# **Final Statement of Reasons for Rulemaking Including Summary of Comments and Agency Responses**

**Public Hearing to Consider the Proposed Heavy-Duty Engine and Vehicle  
Omnibus Regulation and Associated Amendments:**

Public Hearing Date: August 27, 2020  
Agenda Item No.: 20-8-2

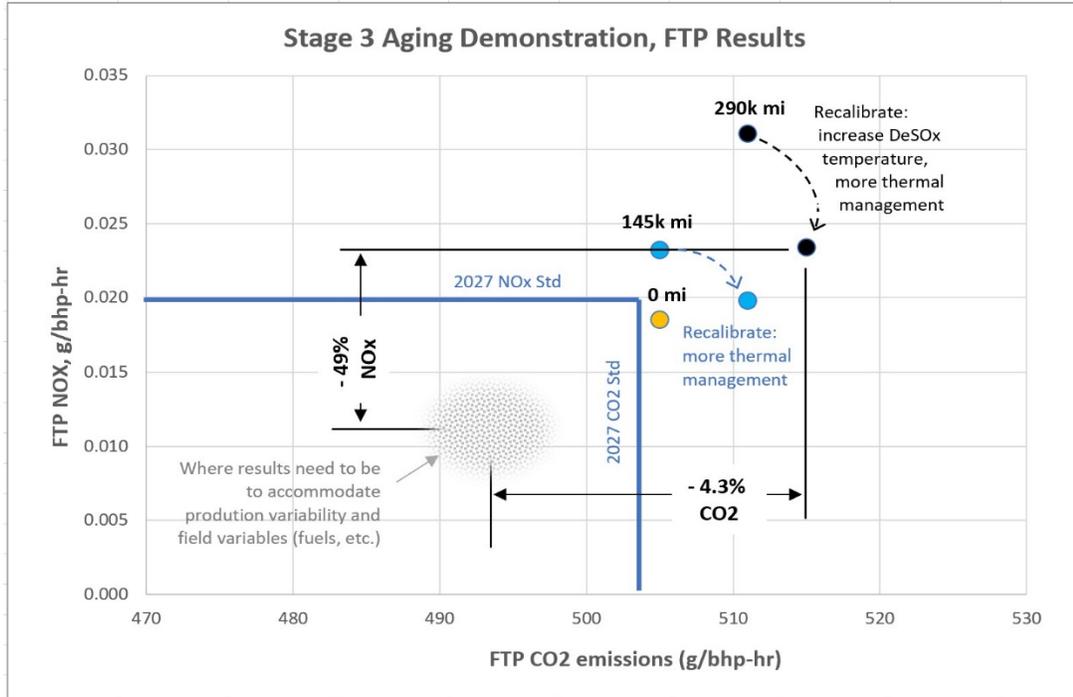
- (a)v.11. Comment: A closer look at SwRI's aging-demonstration test results reveals significant concerns about the inability of the Stage 3 engine and aftertreatment hardware to maintain even marginally-compliant results for just a portion of the proposed FUL requirements. In its July 2020 program update webinar,<sup>51</sup> SwRI presented the results of the FTP, RMC and LLC certification tests of the Stage 3 prototype at the initial "zero hour" and subsequent intermediate test points. The figure below shows the FTP NOx and CO2 results when plotted against CARB's proposed 2027 NOx and CO2

standards.<sup>52</sup> The zero-hour, 145,000-mile, and 290,000-mile test points are plotted. SwRI performed a DeSOx event to purge accumulated sulfur compounds from the LO-SCR prior to testing emissions levels. The DeSOx event, however, failed to achieve the targeted 525°C exhaust temperature, leaving a level of residual sulfur that led to a 0.038 g/bhp-hr composite FTP result (not shown on the figure below, which is scaled only to 0.035 g/bhp-hr). SwRI then readjusted and reran the DeSOx routine to achieve the targeted 525°C DeSOx temperature, which improved the composite FTP result to the 0.023 g/bhp-hr level plotted at the 145,000-mile point. (See figure's blue dots.) To make up for the non-compliant 0.023 g/bhp-hr result, SwRI then made an additional engine calibration adjustment to add additional thermal management to the hot FTP, improving the composite FTP result to 0.020 g/bhp-hr. That additional recalibration increased CO2 emissions by an additional 1%.

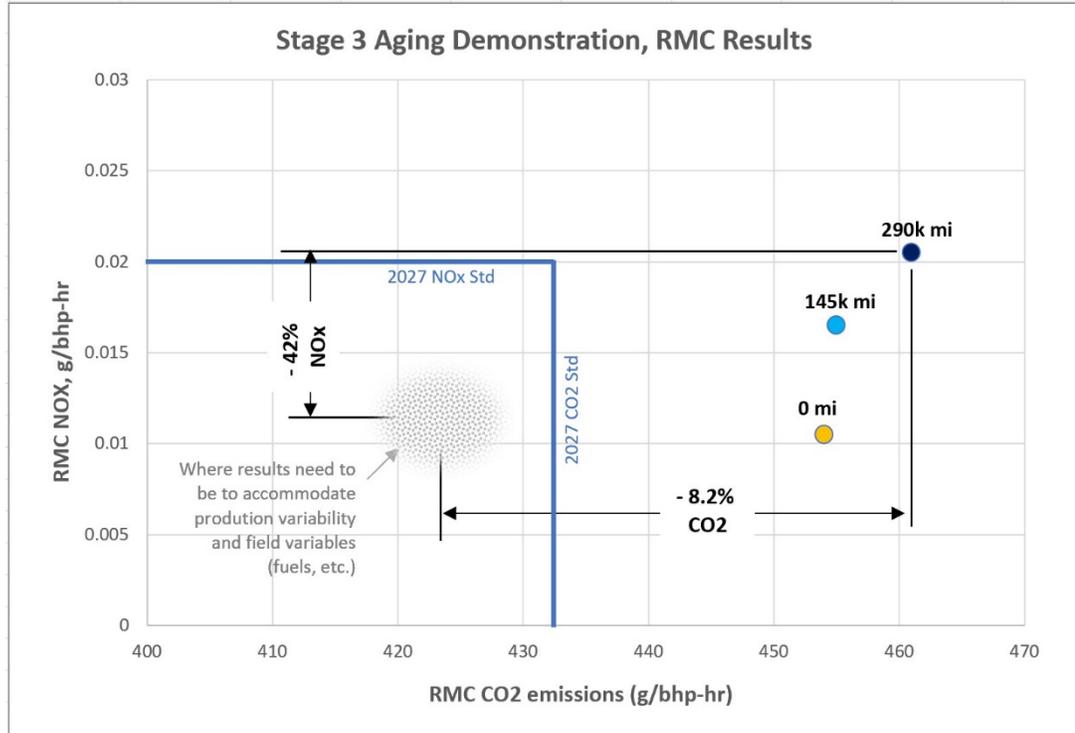
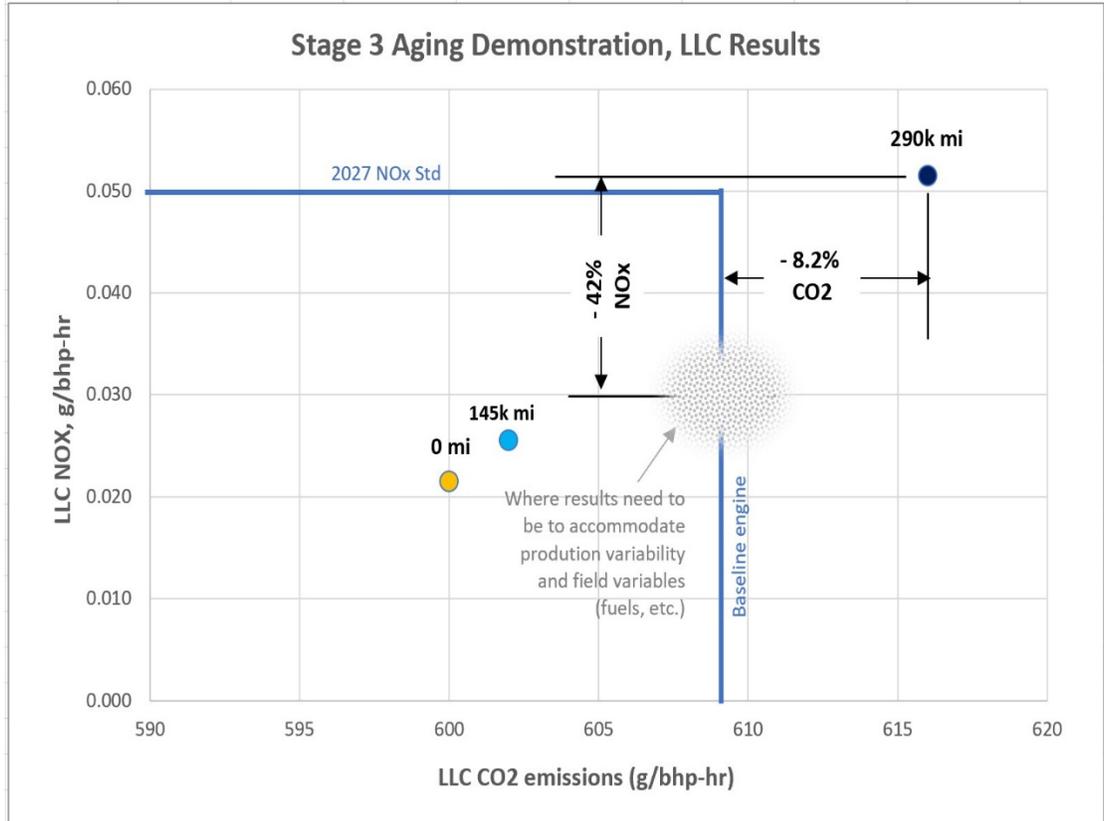
(a)v.12. Comment: SwRI’s RMC results are represented below. There is less detail in the SwRI update concerning the RMC emissions levels that SwRI achieved before the DeSOx temperature improvements described above. (Thermal management recalibrations likely did not impact the RMC results or the engine’s CO2 emissions over the RMC.) Those results, while arguably compliant with the 2027 NOx standard (albeit without any compliance margin), are well in excess of the 2027 GHG/CO2 standard. (EMA, Daimler, Navistar, Volvo)

(a)v.13. Comment: [T]he LLC results that SwRI achieved during its accelerated FUL testing are plotted below. There is no 2027 LLC CO2 standard, so the baseline engine's CO2 emission level over the LLC is represented instead.... Nevertheless, for this purpose, the more conservative baseline CO2 emission level was retained.)

Several observations can be made when reviewing the foregoing data-plots. First, with testing complete only to the level of 290,000 miles, which is only 67% of CARB’s proposed *Intermediate* Useful Life, and just 36% of the 2031 FUL, significant emissions deterioration occurs to the point of NOx-non-compliance on all three compliance tests. Second, the uniformly non-compliant NOx (and CO2) results were achieved even after SwRI made several adjustments to the DeSOx routines and thermal management strategies during the course of the test. Third, for manufacturers to include anything close to the NOx-compliance margins that are necessary (even at the levels needed to ensure FUL compliance at today’s NOx standards, which are 10 times higher than the proposed low-NOx standards), additional NOx reductions on the order of 40% or more would be needed if the significant deterioration trends that SwRI observed continue out to the 435,000-mile test-point. Fourth, the additional 40% NOx-compliance margin would help to account for the observed increases in NOx emissions caused by sulfur compound accumulation and soot accumulation, both of which were mitigated by the high-temperature DeSOx and DPF regeneration events that SwRI performed before each emissions test. While SwRI did not report the even higher emission results immediately prior to those DeSOx and regeneration events, manufacturers’ products necessarily would have to be compliant under those conditions. And fifth, while CARB did not set a goal to meet the 2027 CO2 engine standards in this FUL demonstration, manufacturers nonetheless *must* meet those standards, and will be

**FIGURE 86. HISTOGRAMS OF EST. BSNO<sub>x</sub> FROM MAW ANALYSIS**

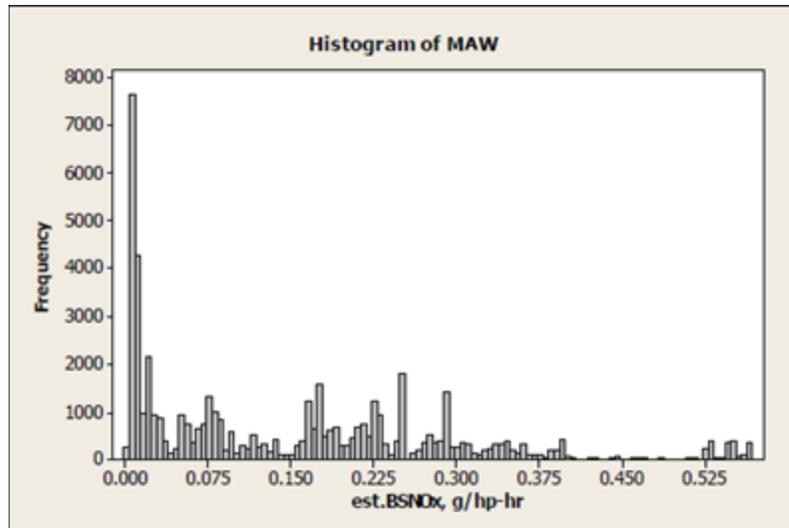
- (b)x.17. Comment: CARB has ignored the recommendations and admonitions of its designated technical experts, and is proceeding forward with a 3B-MAW method that is unsound, underdeveloped, untested and unreasonable. SwRI also highlighted what WVU's analyses have confirmed: the MAW-based method does not yield any clear trends in emissions behavior, and disproportionally weights brief spikes in NO<sub>x</sub> emissions (i.e., NO<sub>x</sub> "breakthrough events"). First, SwRI observed that the MAW-based approach "indicates no clear trend [in emissions] other than a high frequency of very low numbers, but the rest of the distribution is *scattered somewhat randomly* between 0.05 and 0.35 g/bhp-hr." (SwRI Report, ISOR Reference 191, p. 77.) (Emphasis added.) SwRI also noted that the MAW-based approach "provides little information about where emissions are coming from in terms of engine operating modes." (SwRI Report, ISOR Reference 191, p. 79.) SwRI depicted that overall randomness in the MAW-based emissions data as follows:

Second, SwRI expressed its clear conclusion (again matching WVU's) that the MAW-based approach tends to overweight "return to service events after a long low-load period," and that CARB's approach "could result in an overemphasis of those relatively brief spikes in a Low NO<sub>x</sub> environment," with "a large number of windows being driven by a small number of breakthroughs." (SwRI Report, ISOR Reference 191, pp. 66, 69 and 74.)

**Figure IV.A.(f)ii.4.1 Alternative Durability Demonstration Using Accelerated Aftertreatment Aging for 2027 and Subsequent MY Heavy Heavy-Duty Engines**

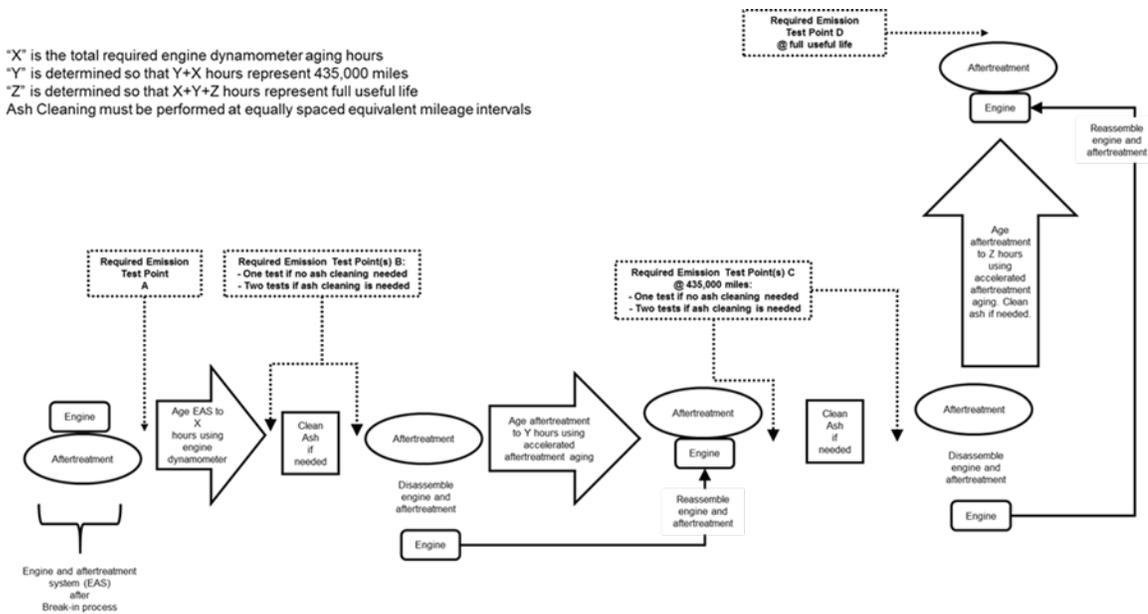
(f)ii.4. Comment: CARB also is defining two different FUL NOx stringencies, one for 2027 to 2030 MYs, and one for 2031 and later model years. For a HHDD engine, one standard will apply up to 435,000 miles of useful life, and a second, higher standard for the remainder of the fully-extended FUL. The Omnibus Regulations do not address this “two-stage” aspect of the NOx standards as it relates to the determination of the DFs for NOx. CARB should include clear DF testing and application requirements as applied to the proposed two-stage FUL standards. (EMA, Daimler, Navistar, Volvo)

Agency Response: CARB staff did not make any changes to the Proposed Amendments based on this comment. The sequence of the required emission testing points for 2027 and subsequent MY HHDD engines is described in Figure CA26-5 of the Diesel Test Procedures. This figure is relabeled as Figure IV.A.(f)ii.4.1 and is shown below:

As depicted, the Omnibus Regulation requires an emission test to be performed at the equivalent 435,000 miles interval (emission test point C). Data from emission test points A, B and C can be used with a linear regression model as described in subparagraph §86.004-26.B.1.3 of the Diesel Test Procedures to calculate the applicable DF value at the 435,000 mile interval.

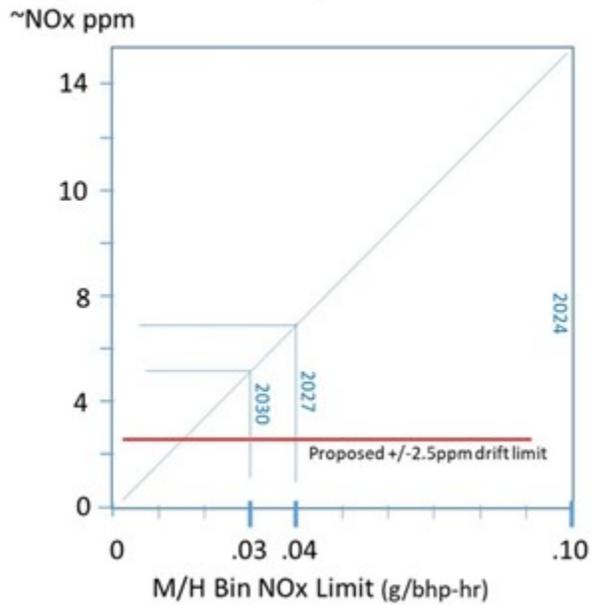
(b)vii.1. Comment: §1065.935.B.2.: CARB has proposed to modify the provisions related to PEMS drift correction for [nitrogen monoxide] NO, NO<sub>2</sub>, and NO<sub>x</sub>. EMA has a number of concerns regarding the proposed drift correction process, including the following issues.

We appreciate that CARB has recognized the significant impact that PEMS NO<sub>x</sub> measurement drift can have on the measurement accuracy, which is critically important in the context of the very low NO<sub>x</sub> levels that PEMS will need to measure and record, and the very stringent standards established under the Omnibus Low NO<sub>x</sub> Regulations. This is especially true for the Medium/High bin, where the standard requires a maximum allowable average NO<sub>x</sub> concentration of 7 to 8 ppm (MY 2030 and later, when the conformity factor is reduced to 1.5). In light of that ultra-low standard, CARB has proposed to reduce the maximum allowable level of PEMS drift for NO, NO<sub>2</sub>, and NO<sub>x</sub>, from earlier proposed drift levels of +/-5 ppm, to +/-2.5 ppm at any zero-check (relative to the pre-test zero). Emissions recorded when the zero-check has exceeds +/-2.5ppm would be invalid. The remaining valid data would be corrected by Equation 1065.672-1.

As can be seen from the RMC emissions test results generated with the SwRI Stage 3 engine (set forth in the table below), NO<sub>x</sub> levels of 1 to 3 ppm will necessarily dominate most Bin 3 operation if compliance it the be achieved. Consequently, it will be critical to accurately measure those 1 to 3 ppm NO<sub>x</sub> levels, so that the day’s average emissions in the bin (including inevitable transient NO<sub>x</sub> breakthroughs, for example, during a “return to service” event following a period of extended idling or coasting), can reliably demonstrate a passing level. Very small errors of +1 to +2 ppm (after correction) when measuring 3 ppm or lower NO<sub>x</sub> levels, will almost certainly lead to determinations of Bin 3 noncompliance for engines which are actually meeting the standard. This issue goes to the core of the likely infeasibility of the Bin 3 requirements.

Proposed PEMS NOx zero-drift limit compared to in-use Medium/High Bin NOx standards.

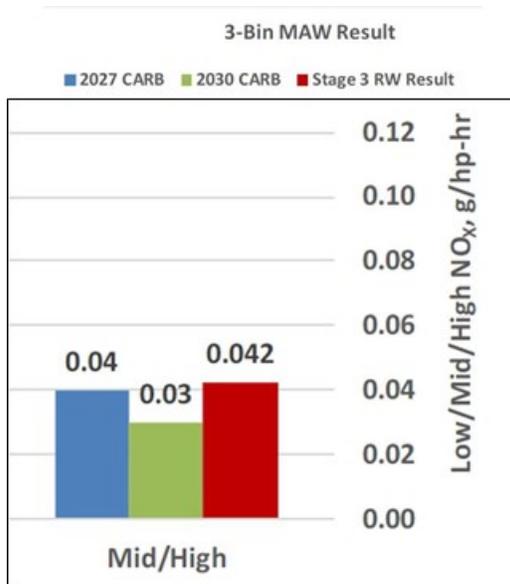
The scale of the maximum allowable PEMS NOx zero-drift during a test-day relative to the very stringent Medium/High Bin in-use NOx limits is shown in the following graph, and clearly reflects the extreme sensitivity of Bin 3 NOx compliance to zero-drift.

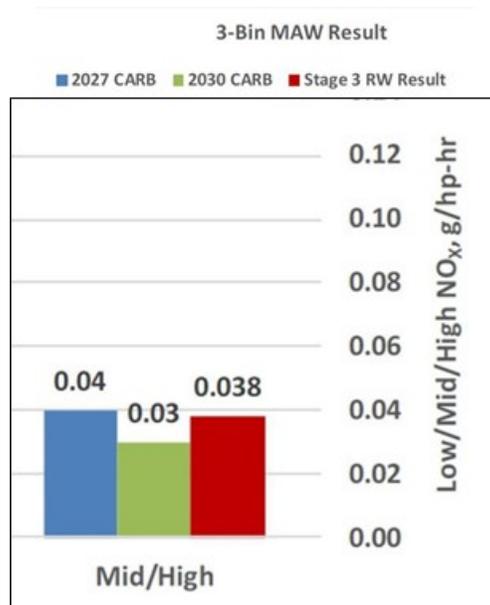
The 3B-MAW Medium/High Bin NOx standards are so challenging that the SwRI Stage 3 engine and aftertreatment system developed and calibrated for the specific purpose of demonstrating the feasibility of the Omnibus Low NOx standards is actually incapable of meeting the 2031 and later in-use requirements for two of five routine road-cycle applications when assessed after 435,000 miles of aftertreatment aging (even before considering CARB's extended FUL and durability demonstration requirements). The Medium/High Bin results from SwRI's testing for the Drayage Cycle developed by West Virginia University are shown here:

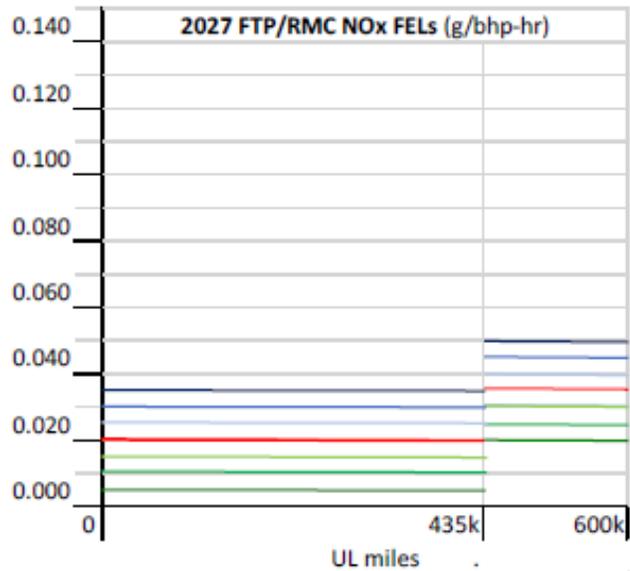
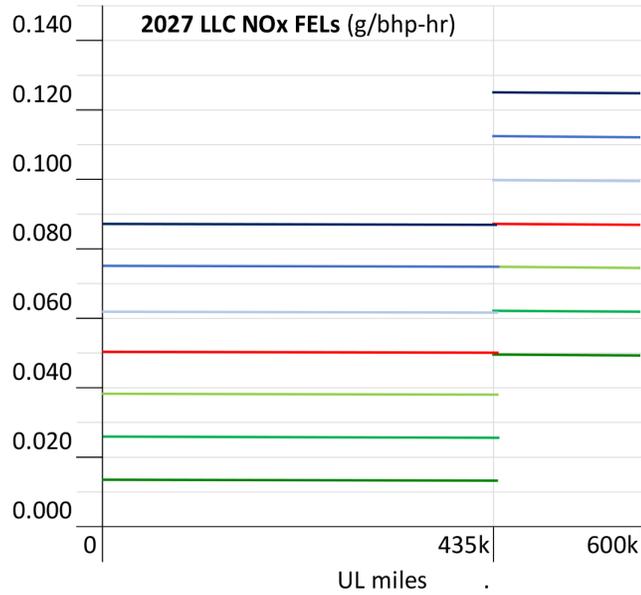
If CARB were to accept EMA’s recommendation regarding the NOx FEL calculation methods of §86.xxx-15.B.3.(i)(4) below, then the 2027 FUL NOx FEL cap would be as follows:

Agency Response to Comments (e)i.4 and (e)i.5: Based on these comments, CARB staff has revised the FEL caps for 2027 and subsequent MY HHDD engines to establish parity with other primary intended service classes.

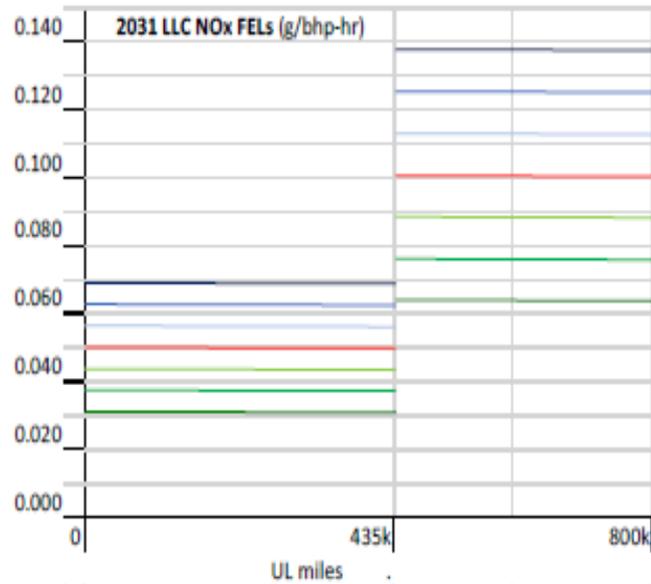
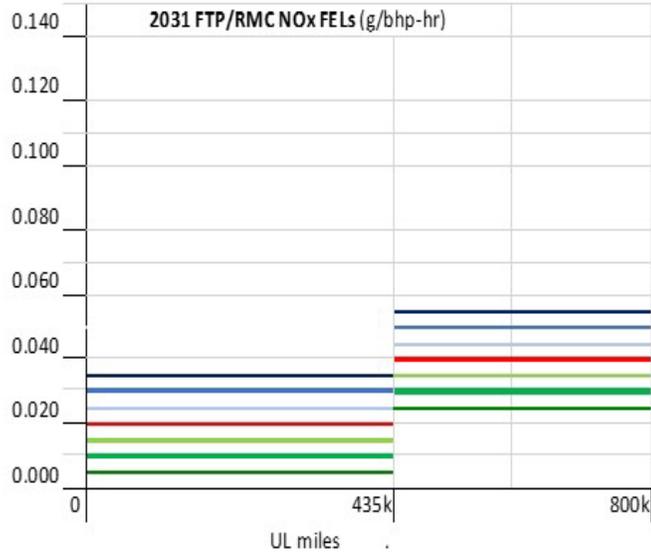
A similar table of potential NOx FELs for 2031 and later standards, and similar graphical representations of those FELs, are shown here:

EMA believes that establishing IUL NOx FELs based on the ratio of the FUL to IUL standards is a more rational approach than the one proposed in the 30-Day Notice. EMA recommends CARB adopt this preferred approach for determining FELs in the Final Rule. (EMA)
